<b>ITEM: 6.4</b>	<b>COMMITTEE OF ADJUSTMENT REPORT SUMMARY MINOR VARIANCE APPLICATION FILE NUMBER A136/23 69 KINGLY CREST WAY, WOODBRIDGE</b>
------------------	--

**COMMITTEE OF ADJUSTMENT REPORT  
MINOR VARIANCE APPLICATION  
A136/23  
69 KINGLY CREST WAY, WOODBRIDGE**

<b>ITEM NUMBER: 6.4</b>	<b>CITY WARD #: 2</b>
<b>APPLICANT:</b>	Luigi & Consolata Maffeo
<b>AGENT:</b>	None
<b>PROPERTY:</b>	69 Kingly Crest Way, Woodbridge
<b>ZONING DESIGNATION:</b>	See below.
<b>VAUGHAN OFFICIAL PLAN (2010) DESIGNATION:</b>	Vaughan Official Plan 2010 ('VOP 2010'): "Low-Rise Residential"
<b>RELATED DEVELOPMENT APPLICATIONS:</b>	None
<b>PURPOSE OF APPLICATION:</b>	Relief from the Zoning By-law is being requested to permit a covered shed, including roof overhang.

**A136/23**

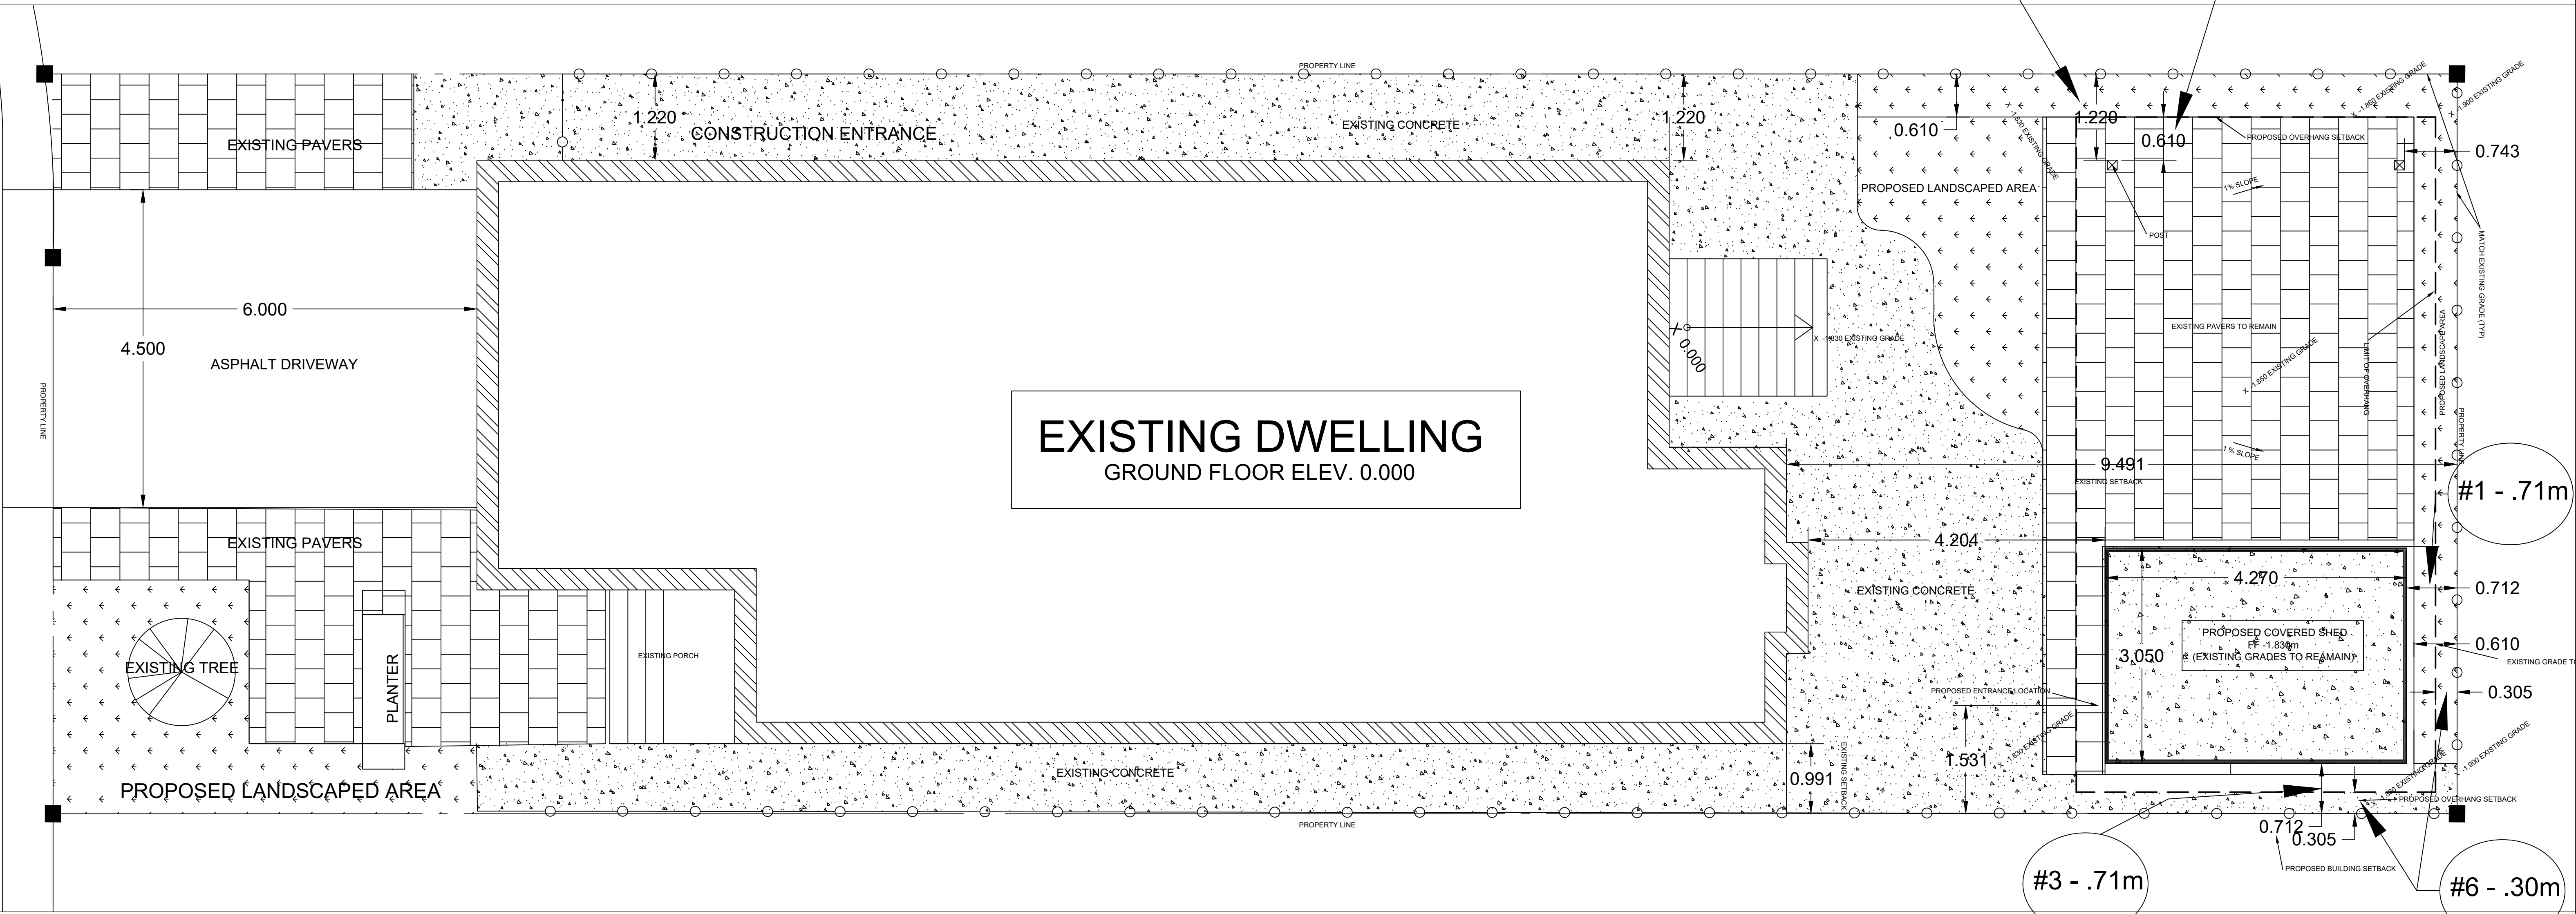
On November 28, 2023, Development Planning provided:  
It has been noted that there is a minor discrepancy in the length of the structure in the two drawings provided (site plan vs builders sketch – see both snapshots below). Please confirm which structure dimensions and eaves overhangs provided are accurate.

Please also note that staff have used the rear lot line measurement from the property survey in order to determine the length of the structure (by subtracting the requested setbacks on both sides of the structure from the rear lot line on the survey: 10.40 metres).

On November 29, 2023, the applicant provided revised plans to address Development Planning comments on November 28.

On November 29, 2023, Zoning confirmed no change to variances based on the revised submission.

**A136/23**

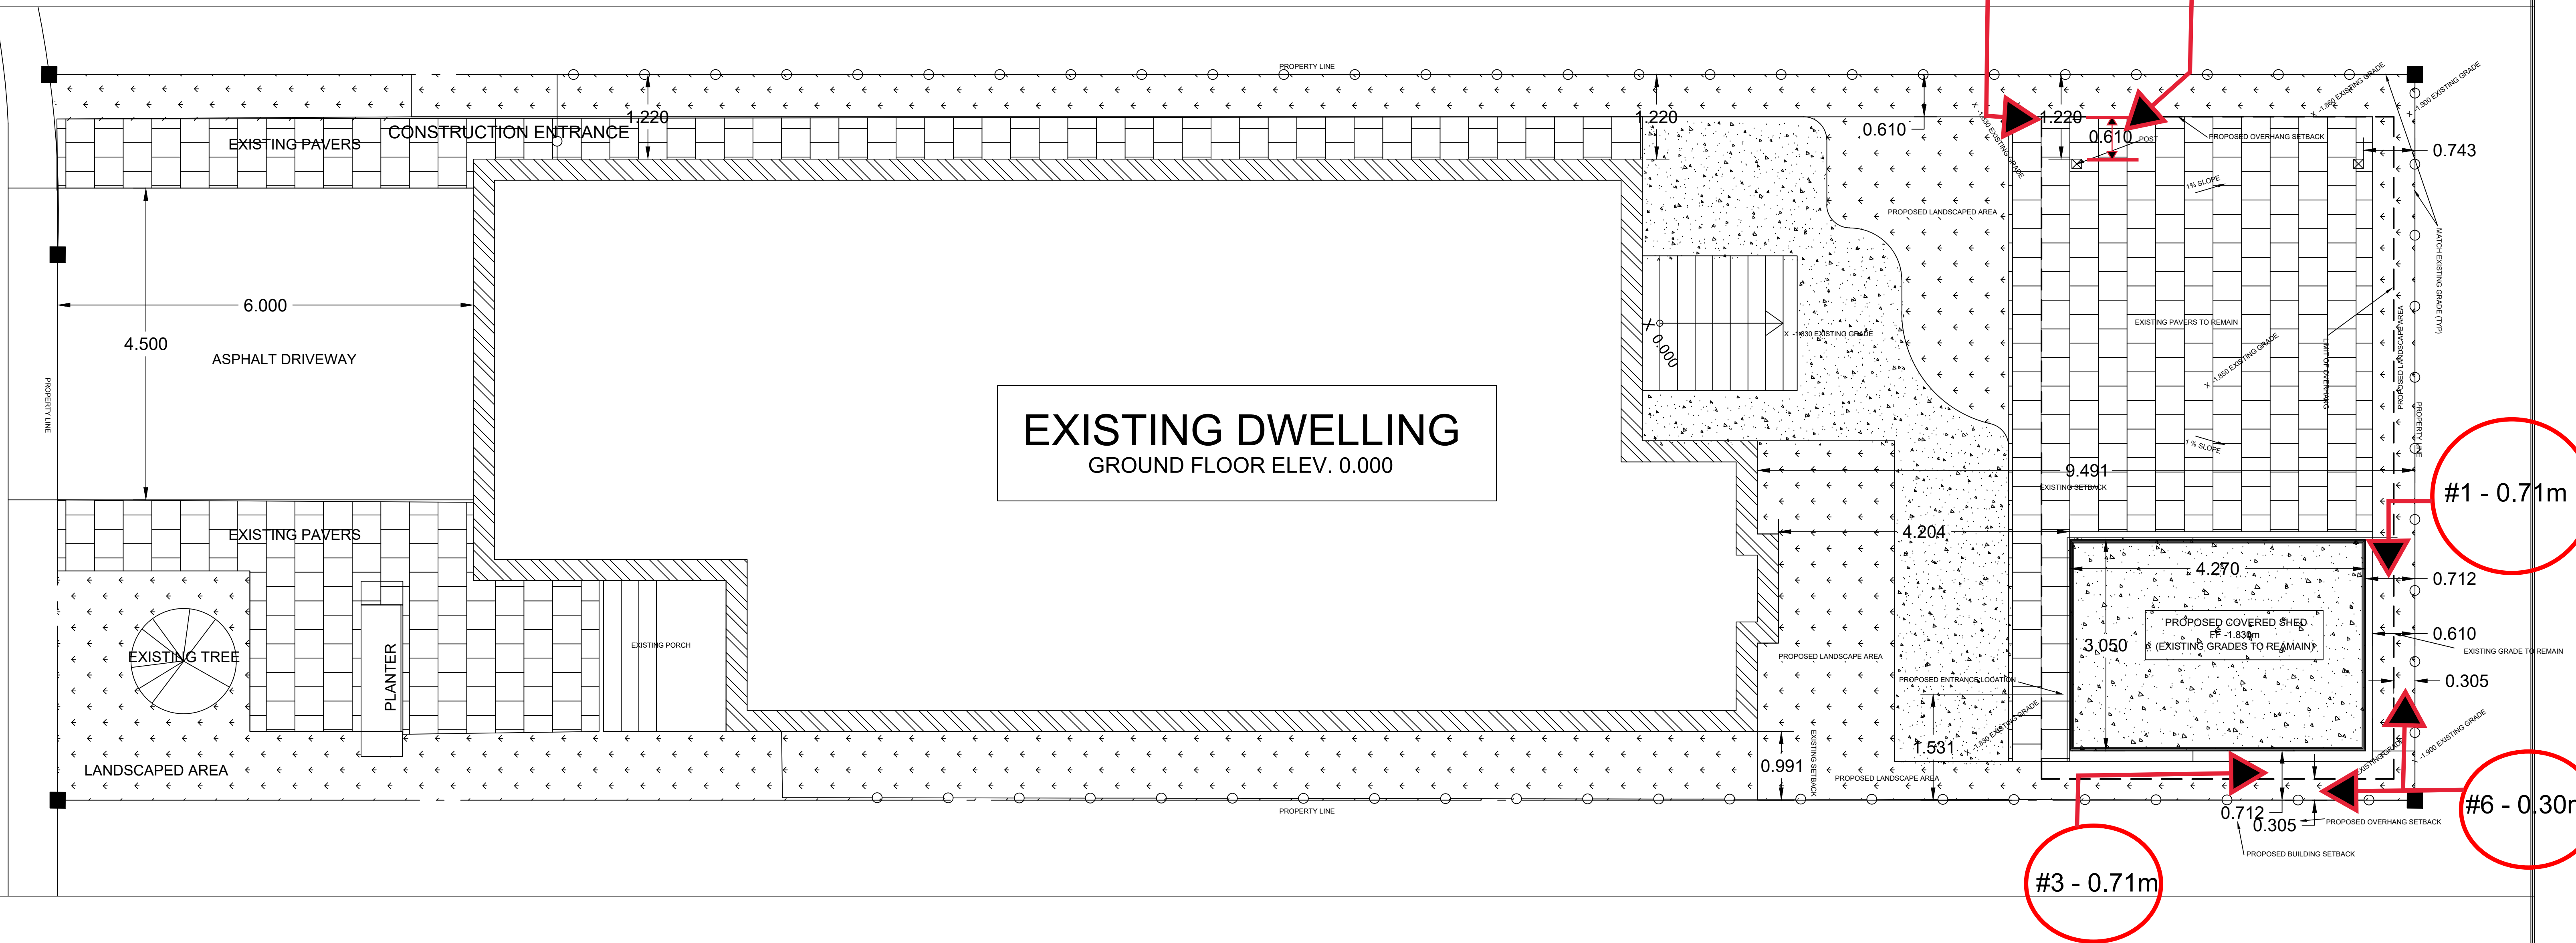
The Development Planning Department is not in a position to support Variances 1, 2, 3, 5, and 6 for the reduced rear and interior side yard setbacks to the accessory structure. The 2.9 m high structure has a flat roof design and contains an enclosed storage room and a covered outdoor lounge area. The 9.49 m length of the structure, inclusive of eaves, occupies about 91% of the rear yard's 10.4 m width. The rear yard of the subject property abuts neighbouring rear yards to the north and south and an interior side yard to the east. The structure's length relative to the length of the rear lot line, in combination with its proximity to the side and rear lot lines and its overall footprint results in a significant amount of massing and privacy impacts.

The structure, in its existing state, occupies most of the rear yard. The rear yard depth (without the structure) is measured at 9.49 m from the dwelling to the rear lot line. The structure, inclusive of eaves, is setback approximately 4.09 m from the dwelling (occupying approximately 54% of the rear yard's depth) and as previously mentioned above, it spans about 91% of the rear yard's width. The existing structure generates substantial mass via its built form into the rear yard, impacting the overall function of the rear yard as a landscaped outdoor amenity space. A function of a rear yard is to provide sufficient outdoor landscaped (hard and vegetative surface) space to provide open air amenity and recreational opportunities. It is anticipated that a structure of such scale will also generate use impacts greater than a structure of a smaller size. These more intensive uses also cannot be adequately buffered for reasons identified above. It is of Staff's opinion that this structure impedes the functionality of the rear yard of the subject property as well as neighbouring rear yards. Adverse massing and privacy impacts are anticipated to the abutting rear yards to the north and south and the abutting side yard to the east.

Therefore, for Variances 1-3, and 5-6, it is staff's opinion that permitting a structure of this scale where only a 1.22 m and 0.71 m interior side yard setback as well as a 0.71 m rear yard setback remains, even if eaves were not to be considered, is a substantial deviation from the zoning by-law's intent, is not minor in nature, nor desirable and appropriate for the use of the land.
